EVALUATION OF COOK IPE/HRA MATERIALS

Letter Report to U.S. Nuclear Regulatory Commission  
Office of Nuclear Regulatory Research

Alan D. Swain, Ph.D.

Submitted: May 10, 1994  
Finalized: December 5, 1994

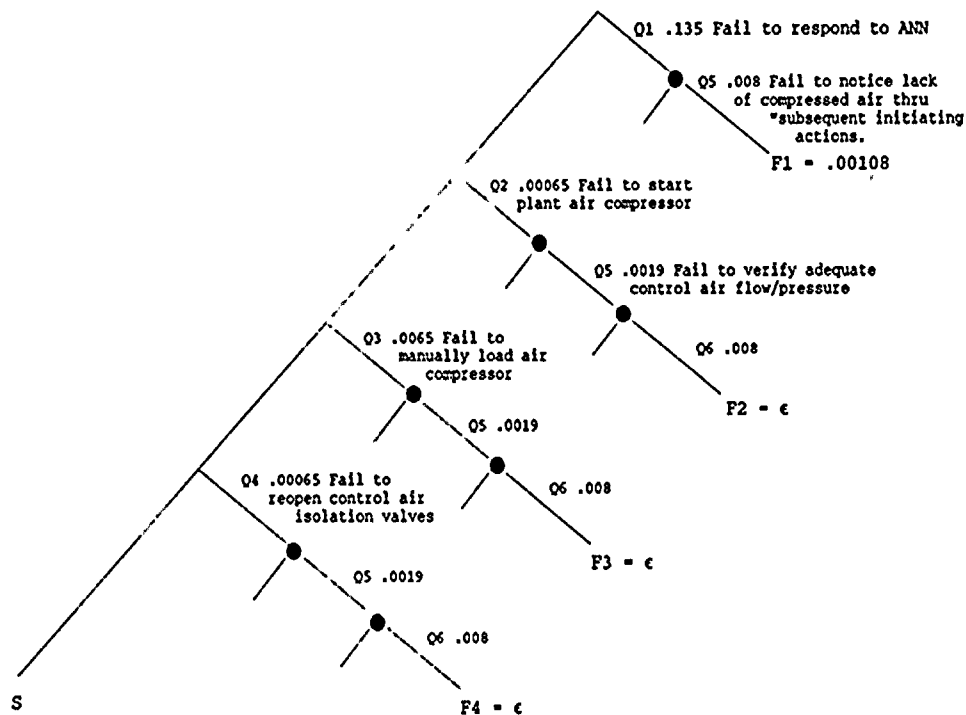
1. pp 41-43, R. Operator Fails to Restore Control Air Through Use of the Plant Air Compressor During Loss of Offsite Power:
  - a. It is difficult to envision the human actions in the equation for the HEP. It would be much easier for a reviewer, especially one with a human factors background or one used to the THERP HRA method, to employ an HRA event tree.

- b. Following is a sketch of an approximate HRA event tree in which only the failure limbs are completely drawn. One can note that each failure path through this series system ends with a potent error recovery factor (RF HEP =  $8E-3$ ). The Q6 error is: "Operator fails to notice lack of compressed air through subsequent mitigating actions (i.e., additional valves will not open)." I don't have sufficient information to evaluate this RF, but it does result in a substantial reduction in  $F_T$ , the total failure probability for this event. Note that were it not for this RF HEP being ANDed with Q1 in the first failure path through the HRA event tree, the .135 HEP for Q1 for diagnosis error would result in a total failure probability,  $F_T$ , for this event being a factor of 125 higher.

- c. There are several misapplication of the HRA Handbook in this event:
    - 1) Q1 is a modification of item #4 in Table 20-3 (the Nominal Diagnosis Model), but the nominal HEP is modified for the effects of stress. This table already includes the effects of stress. Finally, I find the multiplier of 0.1 needs to have believable justification. (See especially the discussion in item 9.d in Table 8-1 of Ref. 4)

- 2) Q2 uses the correct tabled HEP from the HRA Handbook, but the 0.1 multiplier for "trained" is questionable. Normally, if one allows extra credit for a combination of familiarity and high skill, the lower bound of the median HEP would be used. In this case, it would be  $.001/3 \sim 3E-4$ . Well, that seems to work out OK, assuming the use of the lower bound can be justified. The mean HEP would then probably be around the  $6.4E-4$  assessed.

- 3) Q3 sounds like an ECOM, but Table 20-7 is used as the starting point, and this table is for EOMs. I couldn't tell if this action is done in the control room or is it done outside the control room.

- 4) Q4 seems OK except for the 0.1 multiplier for training.
    - 5) Q5 seems OK except for the 0.1 training multiplier. But what directs the operator to perform this step?

- 6) Q6 like all the other terms is multiplied by 0.1 for "trained." This is certainly a convenient way of reducing estimated HEPs, but the use of such a "correction factor" across the board is questionable. Also I wonder how much time is available for this generic RF.

- 7) No dependence is assessed among any of the operator actions. This may be OK; I don't know enough about the details to judge whether it is OK or not. But typically an analyst will assess independence between EOMs for written steps in a procedure. There are exceptions, however.
